Product / Process Change Notification (PCN)	
<input checked="" type="checkbox"/> Major change <input type="checkbox"/> Minor change	
PCN #: PCN_UtRJ45LAN_20230711 Affected Series: WE-RJ45LAN-Series; 749XXX, SXXX PCN Date: April 11, 2023 Effective Date: July 11, 2023	Change Category: <input type="checkbox"/> Equipment / Location <input checked="" type="checkbox"/> General Data <input checked="" type="checkbox"/> Material <input checked="" type="checkbox"/> Process <input checked="" type="checkbox"/> Product Design <input type="checkbox"/> Shipping / Packaging <input type="checkbox"/> Supplier <input type="checkbox"/> Software
Contact: Product Management Phone: +49 (0) 7942 - 945 5001 Fax: +49 (0) 7942 - 945 5179 E-Mail: pcn.eisos@we-online.com	Data Sheet Change: <input checked="" type="checkbox"/> Yes <input type="checkbox"/> No Attachment: <input type="checkbox"/> Yes <input checked="" type="checkbox"/> No

Description and purpose of change: <p>To improve the product reliability, Würth Elektronik will implement a new spot welding design technology. Along with this, further general improvements are done in design and process, like shield plating or wire to shield insulation.</p> <p>

7499111213:

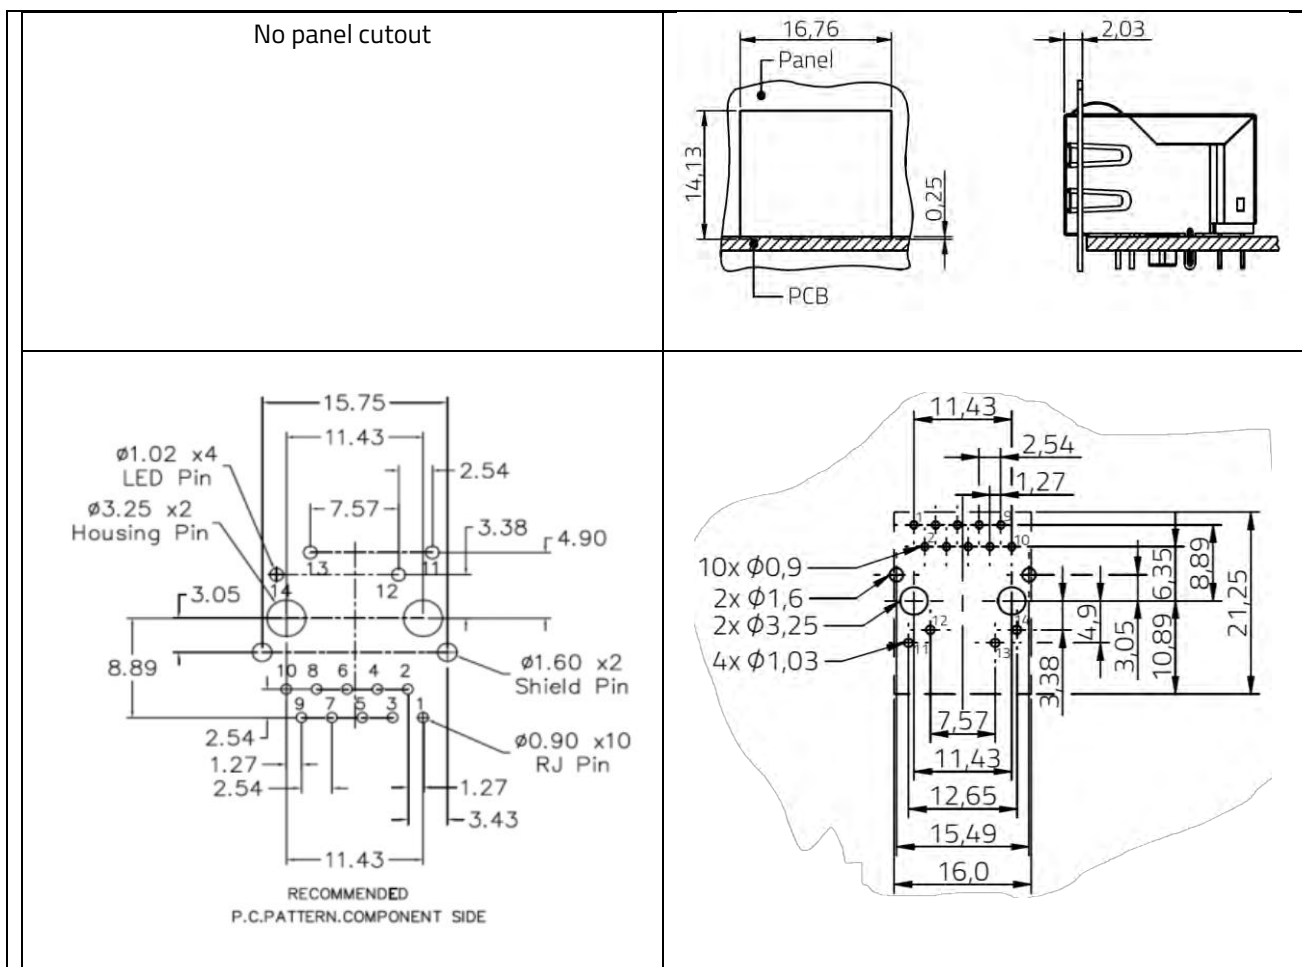
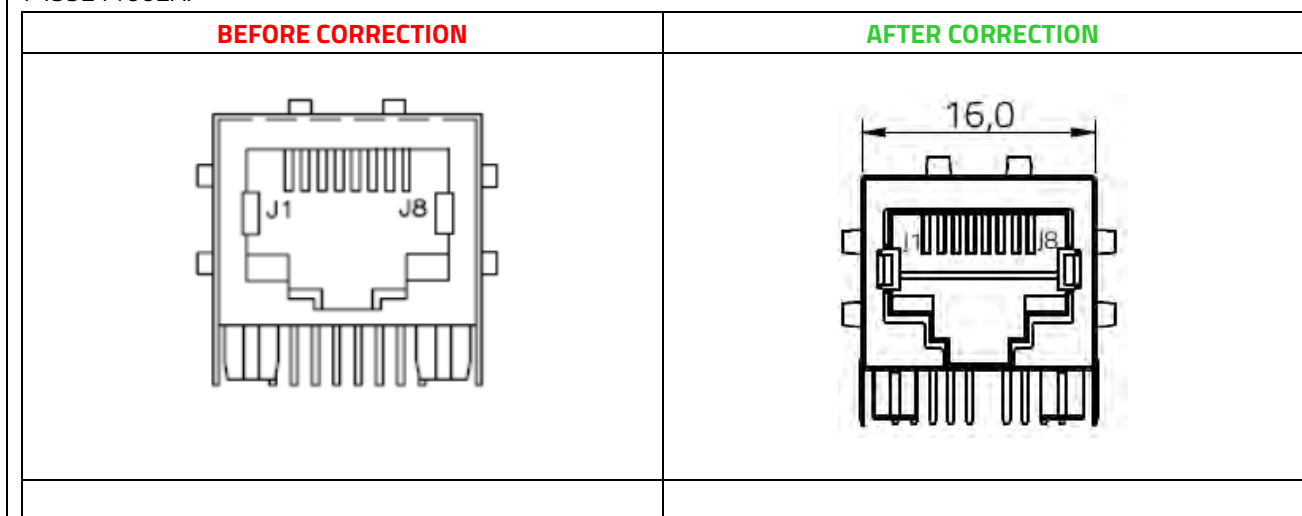
<p>Return Loss: 1-40 MHz 40-60 MHz 60-80 MHz 80-100 MHz</p>	<p>Return Loss: 1-30 MHz 30-60 MHz 60-80 MHz 80-100 MHz</p>
<p>Common Mode Rejection: 1-100 MHz</p>	<p>Common Mode Rejection: 1-30 MHz 30-60 MHz 60-100 MHz</p>
<p>Crosstalk: 1-30 MHz 30-60 MHz 60-100 MHz</p>	<p>Crosstalk: 1-60 MHz 60-100 MHz</p>

S14100074:

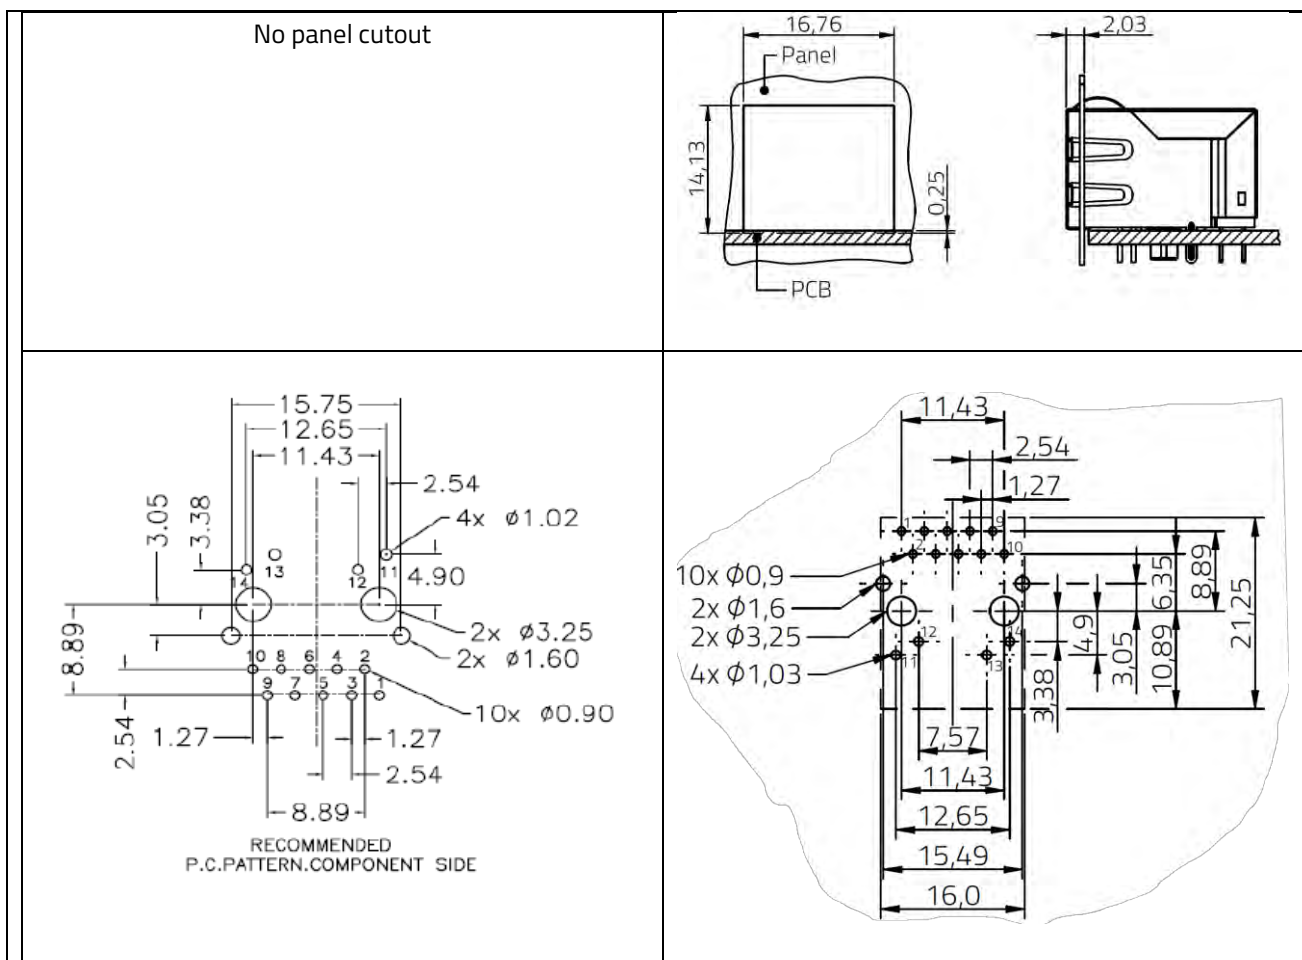
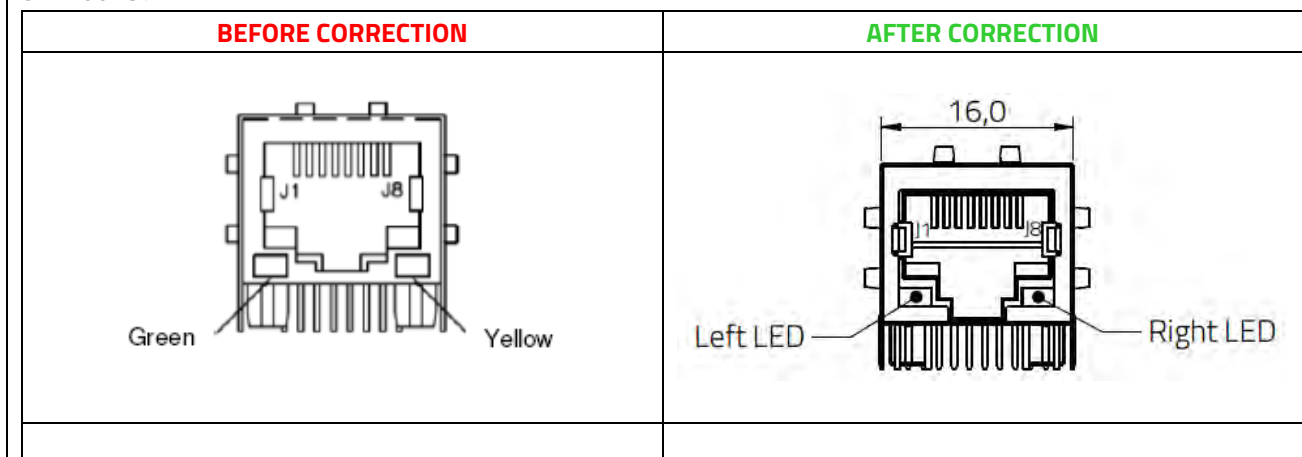
<p>Return Loss: 1-30 MHz 40 MHz 50 MHz 60-100 MHz</p>	<p>Return Loss: 1-30 MHz 30-60 MHz 60-80 MHz 80-100 MHz</p>
<p>Common Mode Rejection: 1-100 MHz</p>	<p>Common Mode Rejection: 1-30 MHz 30-60 MHz 60-100 MHz</p>
<p>Crosstalk: 1-100 MHz</p>	<p>Crosstalk: 1-60 MHz 60-100 MHz</p>

S17100096:

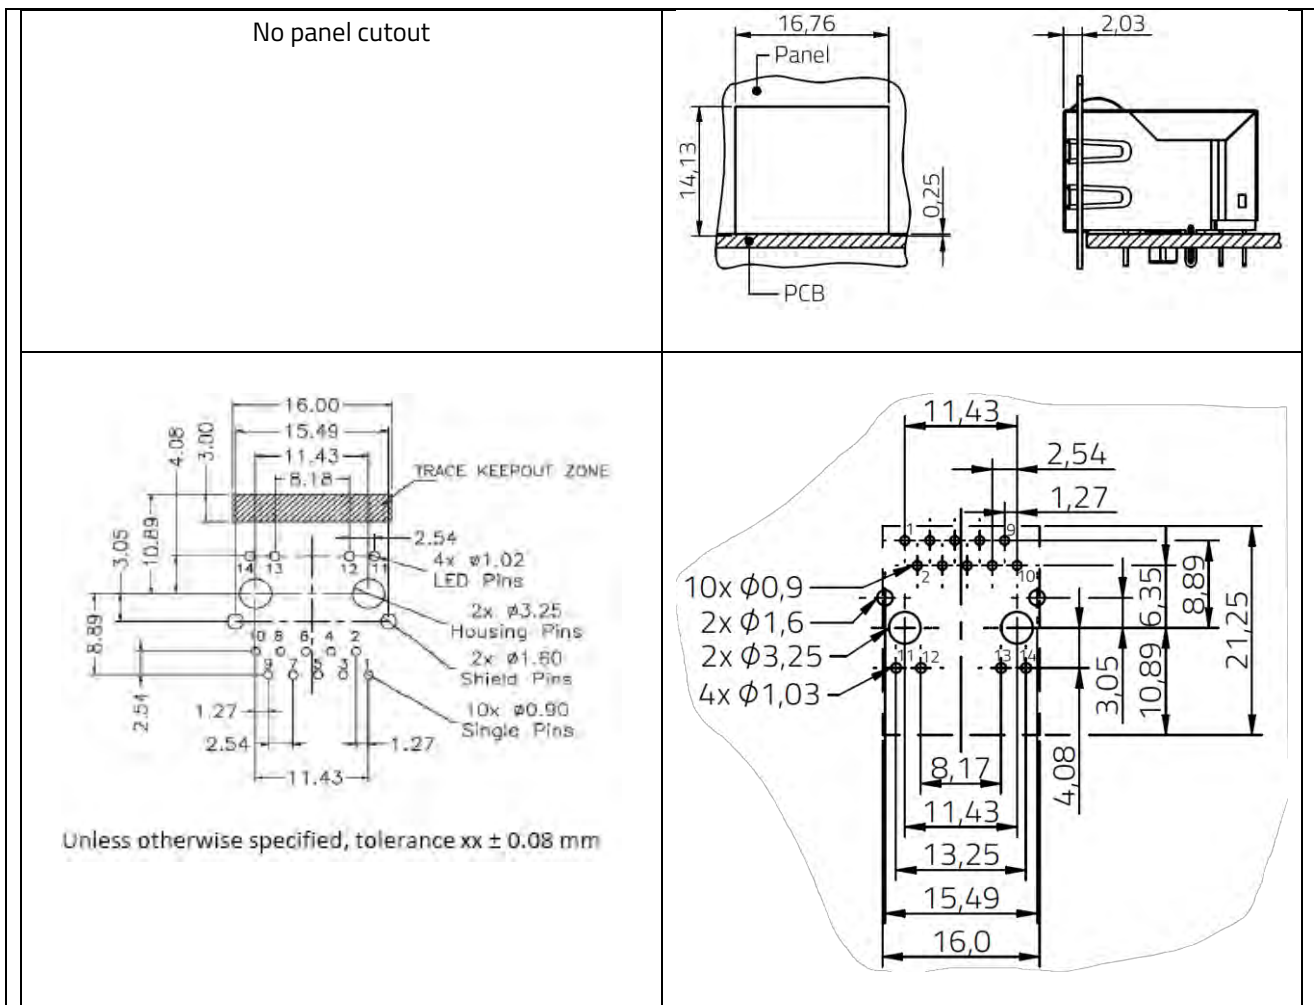
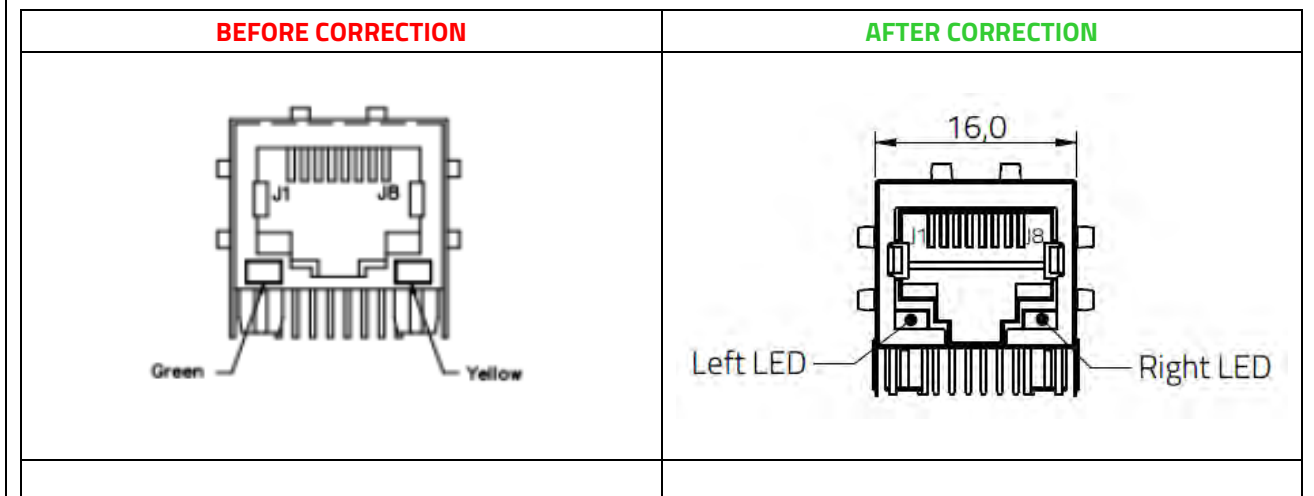
<p>Return Loss: 1-30 MHz 30-60 MHz 60-80 MHz 80-100 MHz</p>	<p>Return Loss: 1-30 MHz 30-60 MHz 60-80 MHz 80-100 MHz</p>
<p>Common Mode Rejection: 1-100 MHz</p>	<p>Common Mode Rejection: 1-30 MHz 30-60 MHz 60-100 MHz</p>
<p>Crosstalk: 1-100 MHz</p>	<p>Crosstalk: 1-60 MHz 60-100 MHz</p>
